Access Compliance Report Public Rights-of-Way (Curb Ramps)

Main Street: E_BOND_AVE Cross Street: N_SWAN_ST Location: NW

ADA ID: RPAT211027135322 Ramp Type: Type 1 - Perpendicular Diagonal Initial Pass/Fail: Pass Overall Compliance: No Severity Score: 0

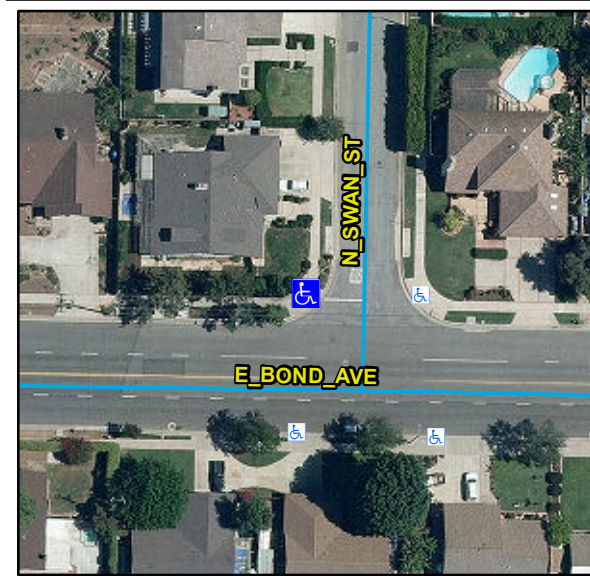
OC Std/PROW:
R304.2.1, R304.5.3, STD 1115

Possible Solutions:
Remove & Replace Landing. Remove & Replace Gutter.
